TAHMOOR COAL MINE LONGWALLS W1-W2 EXTRACTION PLAN Reasons for Approval

- On 16 July 2019, the Department received an Extraction Plan for Longwalls West 1 (W1) and West 2 (W2) in the north-western extraction area of the Tahmoor Coal Mine.

Figure 1: Proposed longwall layout

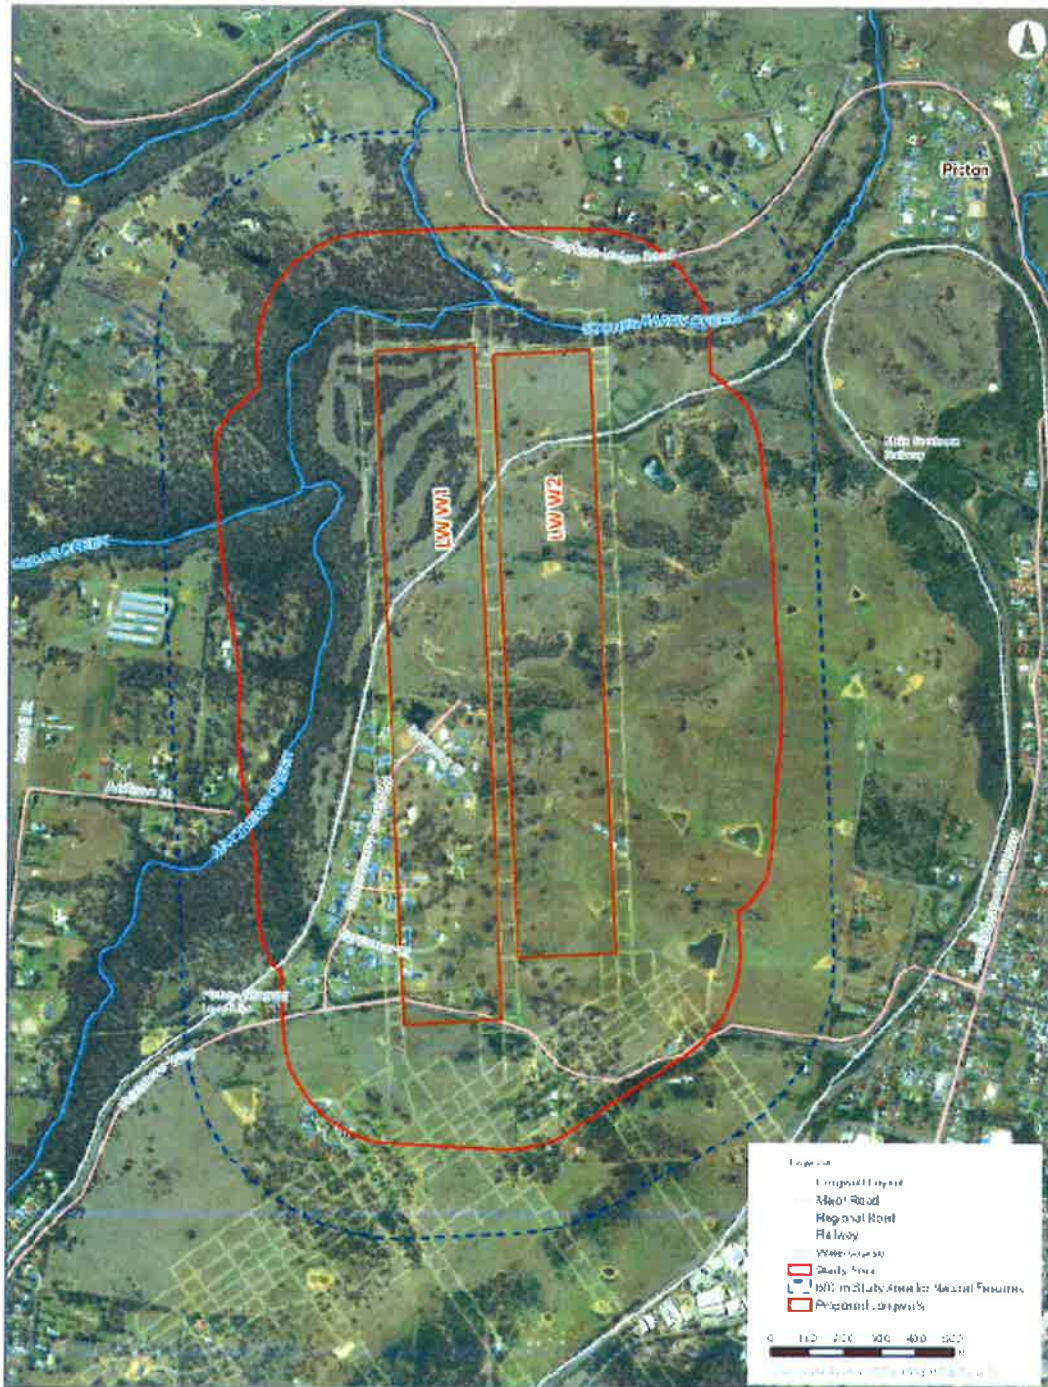
- Since this time, the Western Domain mine plan (i.e. Longwalls W1-W4) has been reviewed and refined. This process resulted in the re-orientation of longwalls from a north-west to south-east orientation to a north to south orientation (see Figure 1).

- These design changes were implemented to avoid direct undermining of third order and above streams and to reduce subsidence-related impacts to Matthews, Cedar and Stonequarry Creeks, which are located along the western and northern areas of the Western Domain. The Department notes that the previous mine plan would have directly undermined these creeks.

- While the revised layout avoids directly undermining several high-order streams/creeks, including Cedar (5th order), Stonequarry (5th order) and Matthews Creeks (4th order), Longwalls W1 and W2 are still in close proximity to these creeks and some surface impacts are still expected.
